Fixing kit for tanks

With the goal of constantly improving the quality of our products and their alignment to the technical equipment of the current ranges of industrial vehicles, we inform you that the fixing kits of the side oil and diesel tanks “JOLLY P” and “BP” will be suspended and replaced with new fixing kits that have the following advantages:

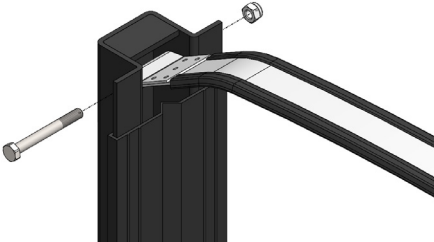
WAS	WILL BE
	<p>Better coupling tank/fixing kit.</p> 
	<p>Improved support profile to allow a smooth fitting.</p> 
	<p>Self-locking pin instead of screw+nut. Allows a reduction in assembly time.</p> 
	<p>Unified mounting kit for all lengths (version with back recesses no longer required).</p>
